AMENDMENTS TO THE DRAWING FIGURES

REMARKS

Dated: February 17, 2006 MacMillan, Sobanski & Todd, LLC One Maritime Plaza, Fourth Floor 720 Water Street Toledo, Ohio 43604 (734) 542-0900 (734) 542-9569 (fax) Title: Universal Joint And Method Of Servicing A Staked Universal Joint
U.S. Serial No. 10/696,791 - Filed: October 30, 2003
Attorney Docket: 46107-0087
Reply To Office Action Dated April 4, 2005
REPLACEMENT SHEET

Fig. 3A

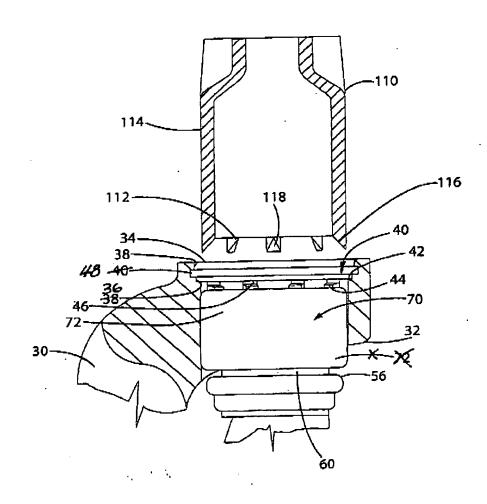
The drawings stand objected to because Figure 3A fails to include the changes made of record in the replacement drawings filed July 1, 2005. The attached Replacement Sheet, is identical to the Replacement Sheet filed July 1, 2005, except that it includes the changes marked in red on the Annotated Sheet Showing Changes. which is an appendix to this amendment.

The drawings stand objected to because Figure 3A fails to include the changes made of record in the replacement drawings filed July 1, 2005. The attached Replacement Sheet, is identical to the Replacement Sheet filed July 1, 2005, except that it includes the changes marked in red on the Annotated Sheet Showing Changes. which is an appendix to this amendment.

The Amendments to the Specification attached with this paper corrects the reference number "40" and replaces it with reference "44".
